Index 700-041 Span Sign Structure

COMMENTS AND RESPONSES

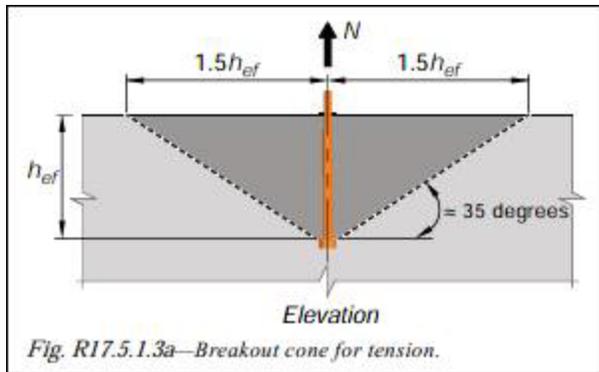
1. Anchor Embedment Length: in 700-040 and 700-041, the anchor embedment is dimensioned from the concrete surface to the bottom of the anchor bolt. While in mast arm standard 649-031, it is dimensioned from the concrete surface to the top of the nut. Suggest reconciling this inconsistency.

FYI, ACI 318-19 Figure R17.5.1.3a shown below measures the effective embedment h_{ef} to top of the head of the headed bolt which is same as for mast arm standard.

RESPONSE: 1. Agree.

Change made to Index: Changed dimension 'BK' extents in Base Plate Connection detail to match calcs.

LAST REVISION 11/01/22	REVISION	DESCRIPTION:		FY 2023-24 STANDARD PLANS	SPAN SIGN STRUCTURE	INDEX 700-041	SHEET 3 of 5

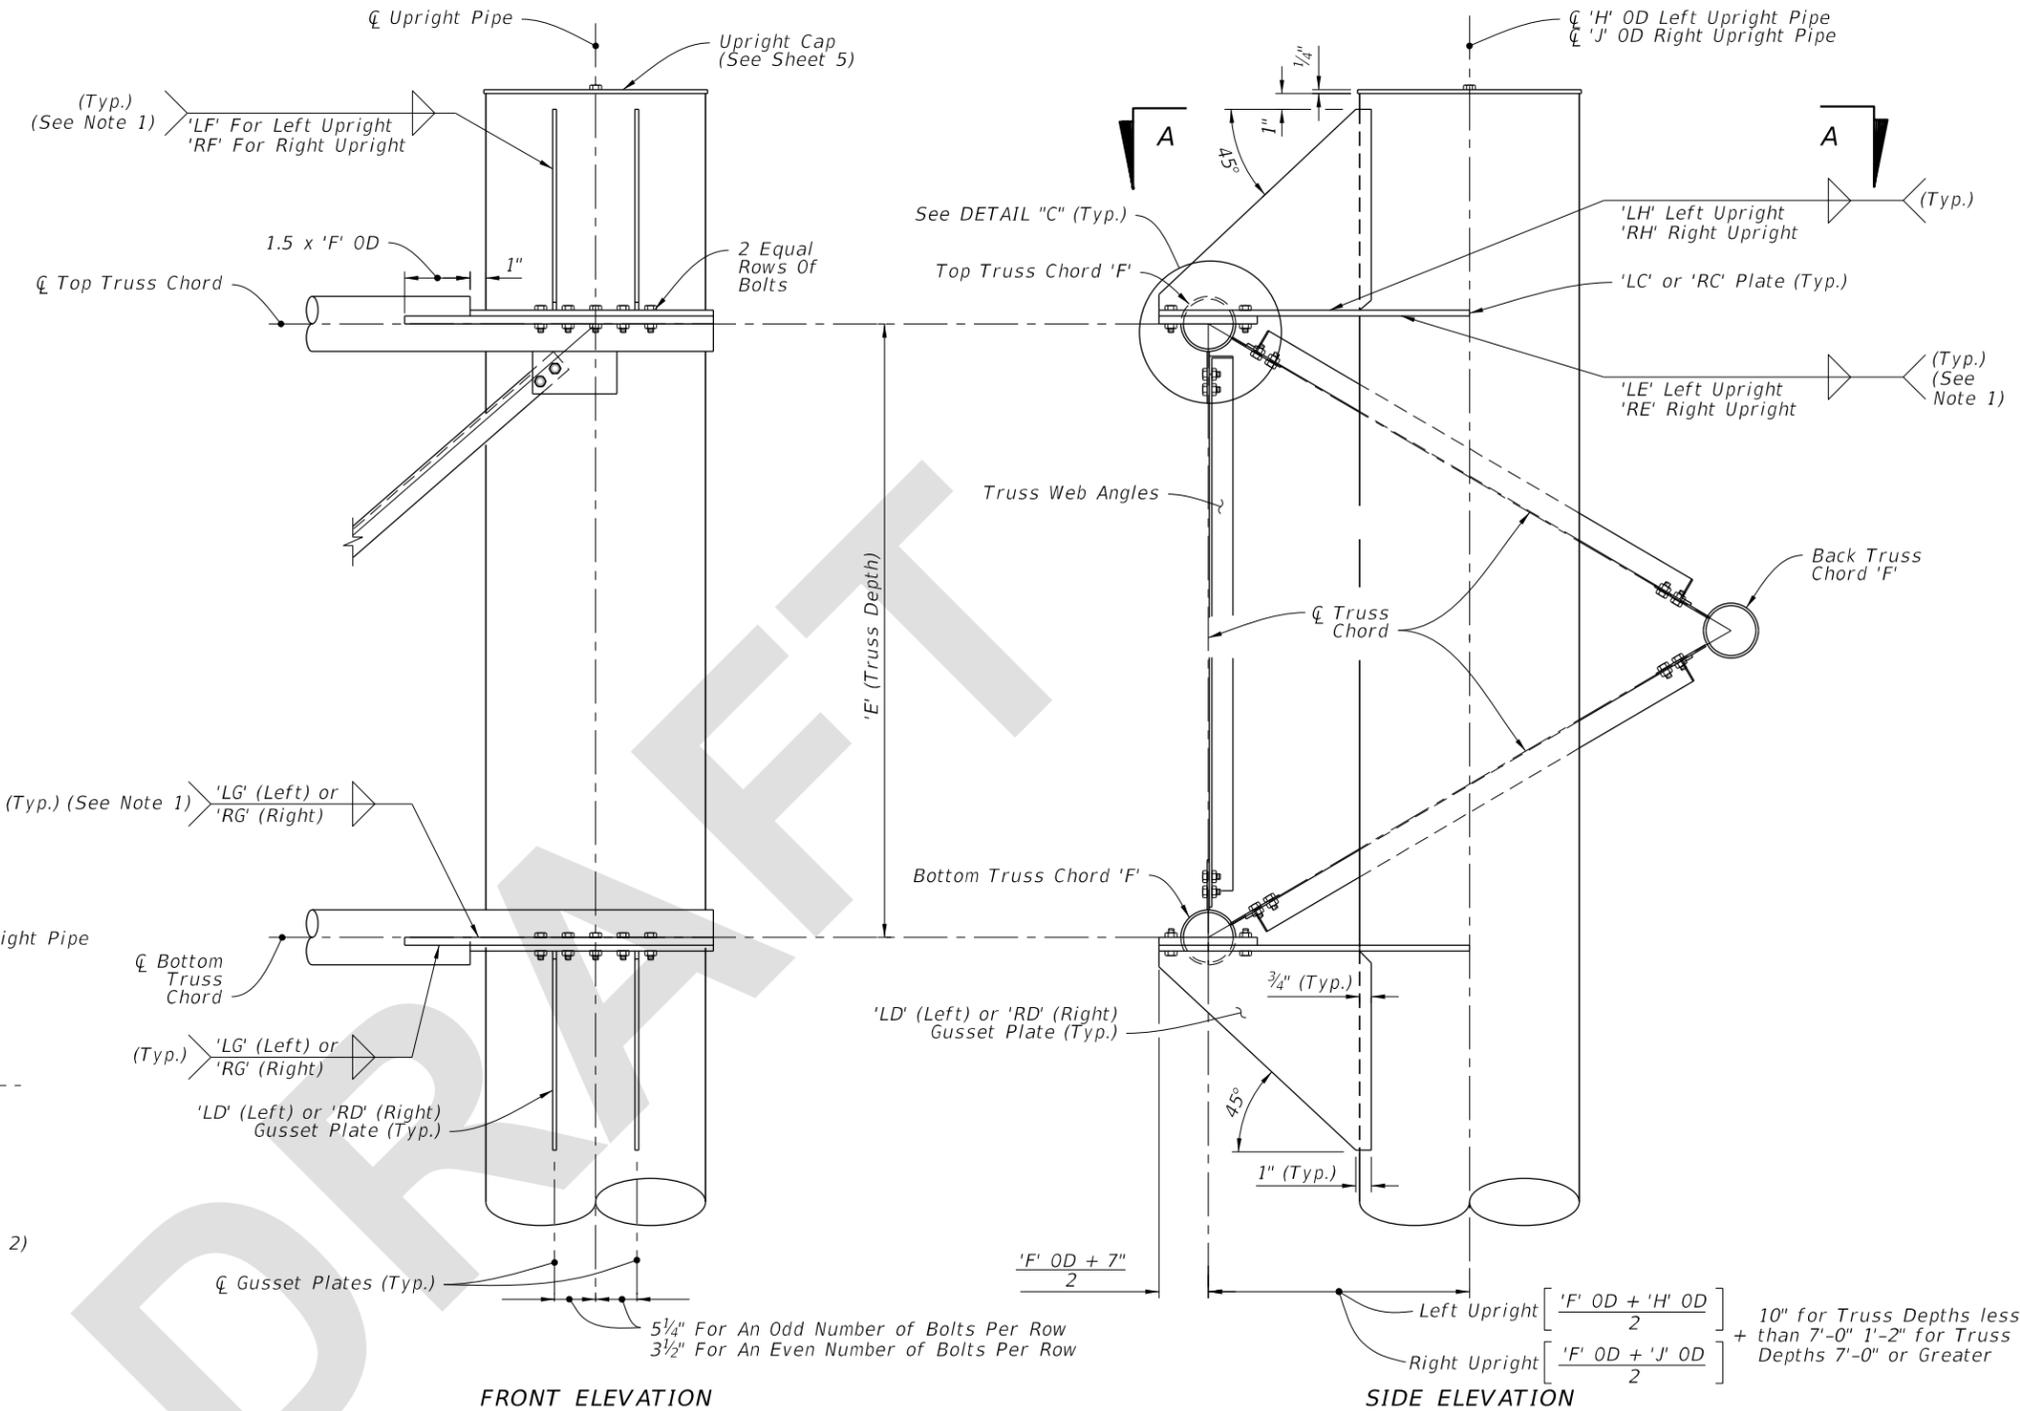
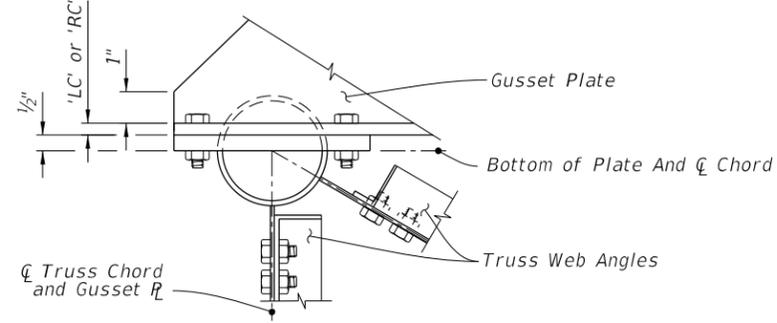
COMMENT: The line work in Section A-A on sheet 3 should be corrected as shown in the markup provided. On sheet 4 an update is needed to the member orientations in Truss Front Elevation to reflect correct geometry.

COMMENT: It's not clear wear welds from plates to tubes should be wrapped.

RESPONSE: Agree. Both changes will be made with the final revisions.

Change made to Index: Update Sheet 3 and Sheet 4 based on comments.

RESPONSE: Standard has been updated to more clearly specify where the welds should be wrapped.

Change Made to Index: Annotations added to UPRIGHT-TRUSS CONNECTION DETAIL Sheet 3

SPLICE CONNECTION DETAIL

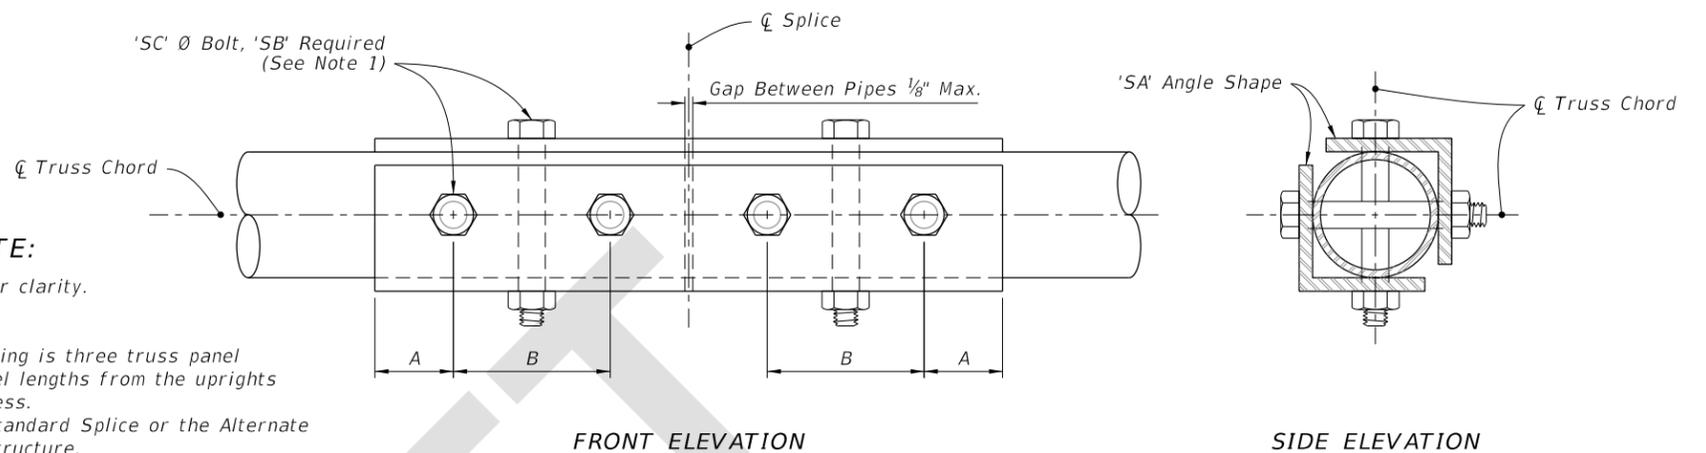
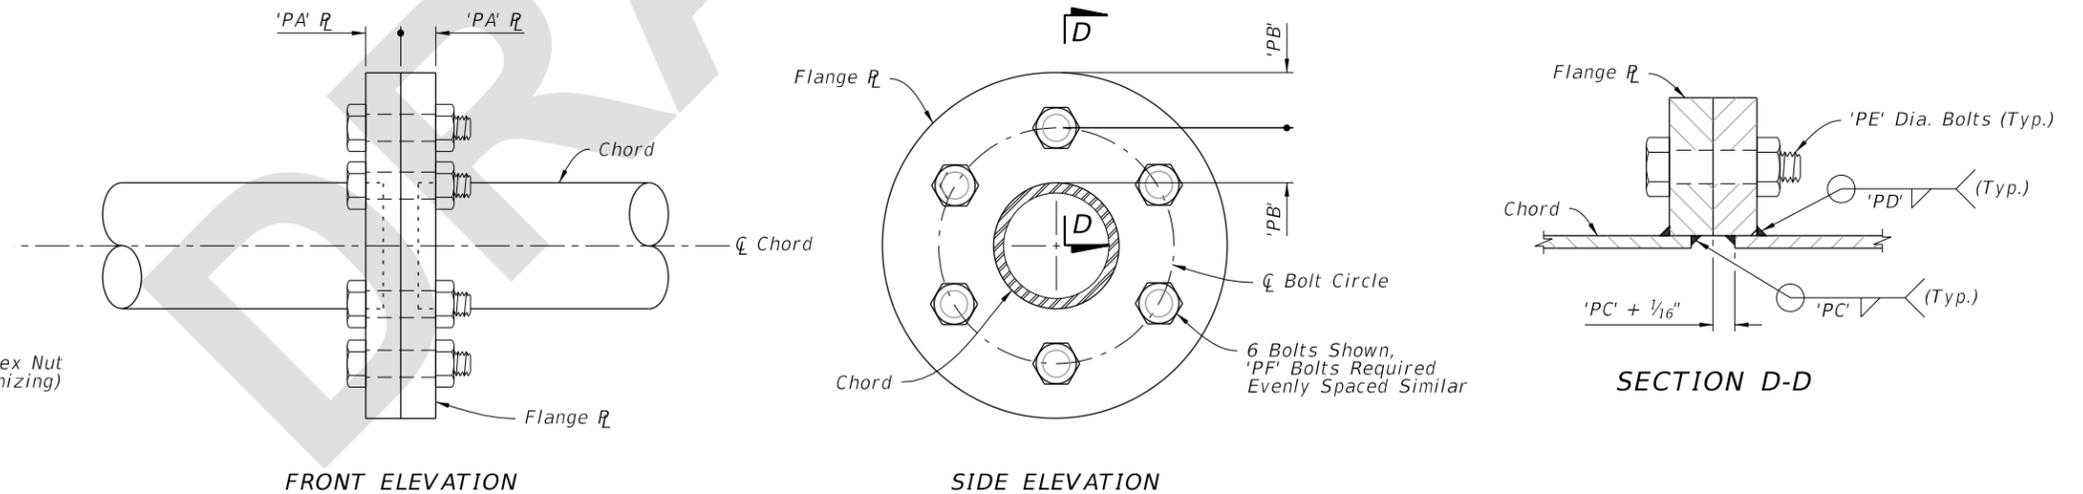
2. In sheet 5 of 700-041, note 3 for upright splice was added as

3. Upright splice: Not allowed unless the upright exceeds available mill lengths (35' - 40').

. While this note was not added to 700-040. Is there any reason that only add this note to 700-041?

2. This note was previously located on Sheet 1 of Index 700-041 in General Note 5. It was moved to sheet 5. The note was not previously included in Index 700-040.
